UNITED STATES PATENT AND TRADEMARK OFFICE

APPLICATION NO.	FILING DATE	FIRST NAMED INVENTOR	ATTORNEY DOCKET NO.	CONFIRMATION NO.
10/826,272	04/19/2004	Kazuhiro Fujii	SN-US045038	9912

Office Action Summary

FIG. 2 BENT SECTION

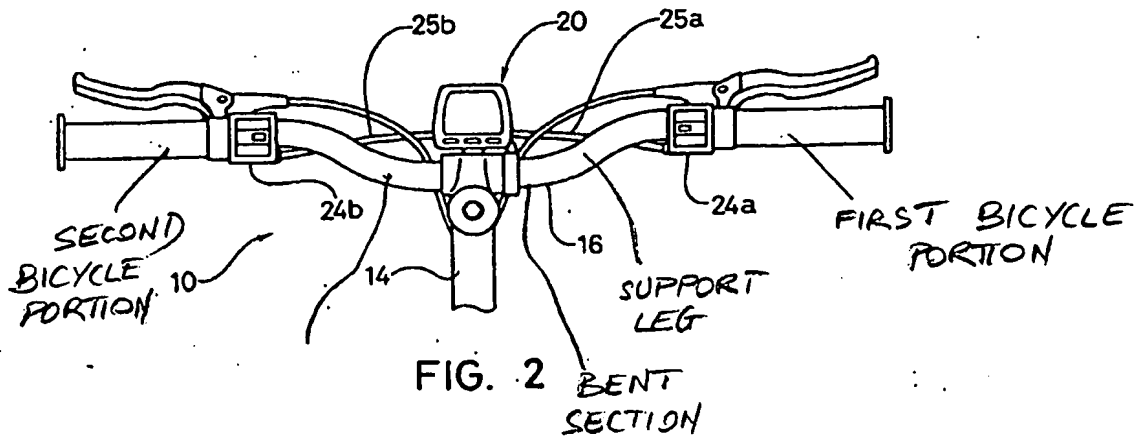
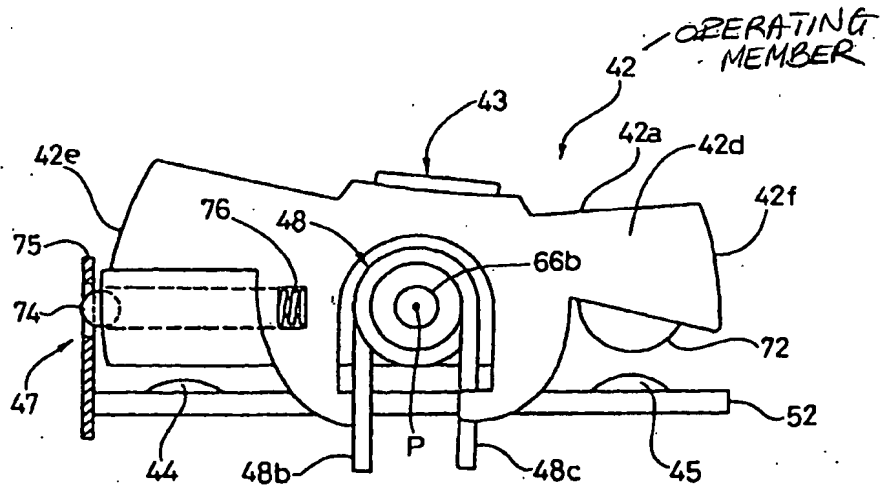
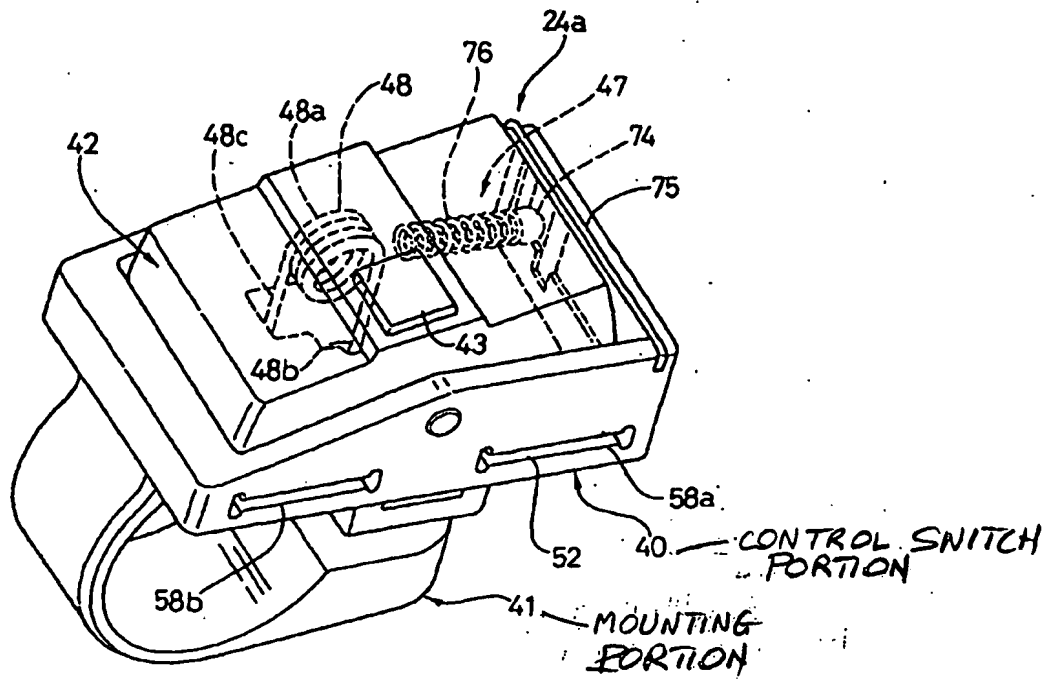
a first shift control device 24a (FIG. 2) including a first mounting portion 41 having a first tubular clamping member 41 (see Attachment hereinafter “Att.”) configured to be selectively clamped onto a bicycle handlebar 16 (FIG. 2) and a first electrical shift control switch 40 attached to the first tubular clamping member 41 of the first mounting portion 41; and

Regarding Claim 12, Ichida teaches second shift control device 24b (*id.* paragraphs [0020] and [0030]) including a second mounting portion 41 having a second tubular clamping member 41 configured to be selectively clamped onto the bicycle handlebar 16 (FIG. 2 of Att.) of the bicycle 10 and a second electrical shift control switch 40 mounted to the second mounting portion 41, the bicycle computer unit being *operatively* supported between the first and second shift control devices 24a and 24b by at least the first mounting portion 40. Note that the first and second shift control devices are substantially identical to each other as described in paragraph [0030].

Regarding Claim 13, the first mounting portion 41 includes a band section (FIG. 9 of Att.) and a computer support leg 16 (FIG. 2 of) extending from the band section, and the bicycle computer unit 20 is attached to the computer support leg 16 of the first mounting portion.

Regarding Claim 14, the computer support leg 16 includes a bent section (FIG. 2 of Att.) such that the bicycle computer unit 20 is longitudinally offset from the band section (FIG. 9 of Att.) along the first bicycle portion (FIG. 2 of Att.).
